**Sub-Slab Vapor and Soil  
Sampling Work Plan  
for Evaluating SVE System  
Effectiveness  
Former Trench Drain Area  
Buell Automatics Site**

BCP Site No. C828114  
381 Buell Road  
Rochester, New York

July 2, 2014

**Re: Buell Automatics Site #C828114  
Brownfield Cleanup Program (BCP)  
Sub-Slab Vapor and Soil Sampling Work Plan for Evaluating SVE System Effectiveness  
Former Trench Drain Area; May 9, 2014  
Town of Gates, Monroe County**

FIGURE 4

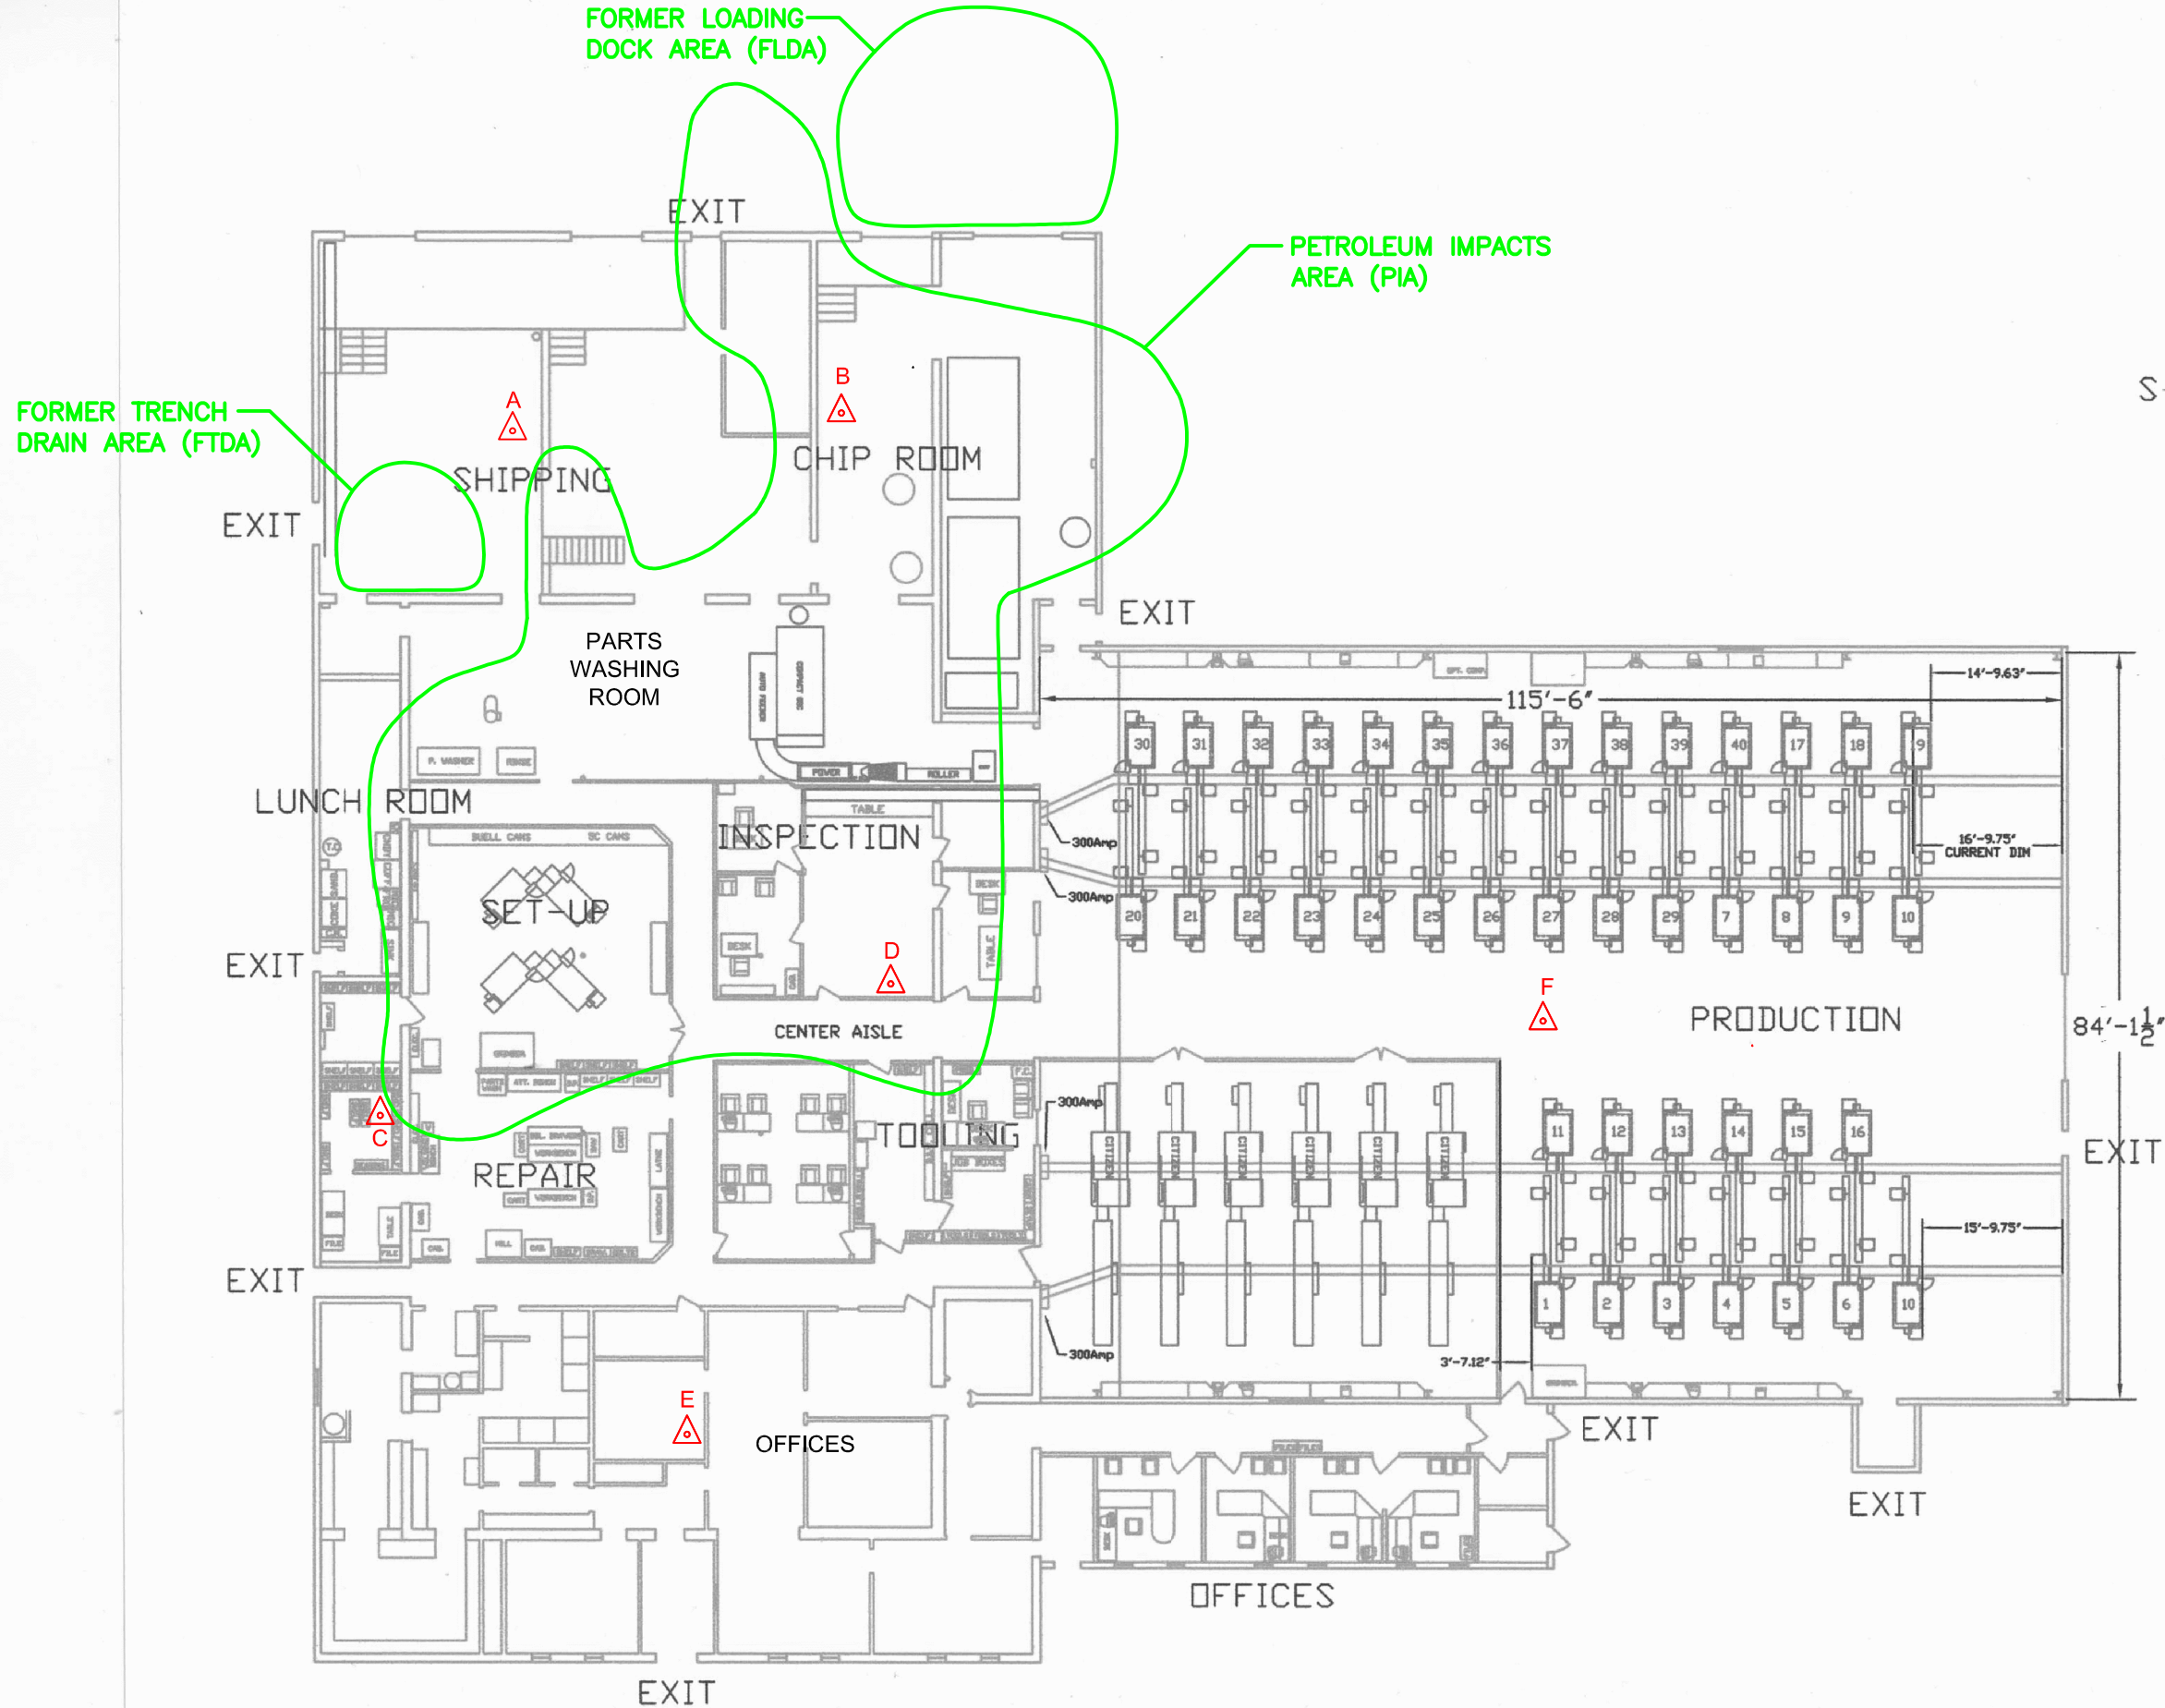
1. **Section 3.0:** The SVI Assessment sampling event will involve collection of samples of sub-slab vapor and indoor air at the six locations (locations A through F on the attached figure) previously sampled in December 2010. The December 2010 sub-slab vapor and indoor air results indicated that mitigation or monitoring may be needed at all of the sample locations except location F. Re-sampling all six locations will help evaluate how subsurface conditions have changed during the time the soil vapor extraction system was in operation, help determine whether any additional actions are warranted, and confirm the location F results.
